Proposed Rear (East) Elevation

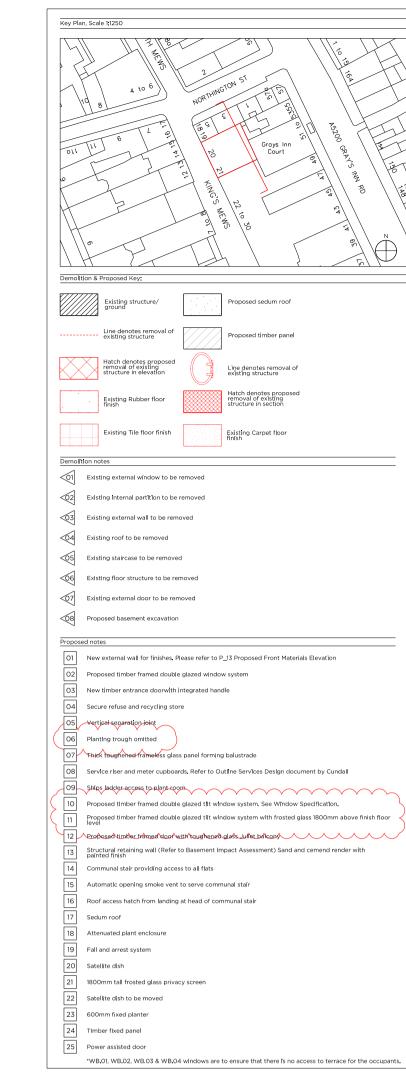
Planter Trough Omitted	23.12.16	Rev E
Elevation revised	01.08.16	Rev D
Acoustic plant enclosure reduced	11.05.16	Rev C
Boundary wa ll updated	21.04.16	Rev B
Issued for planning	19.02.16	Rev A
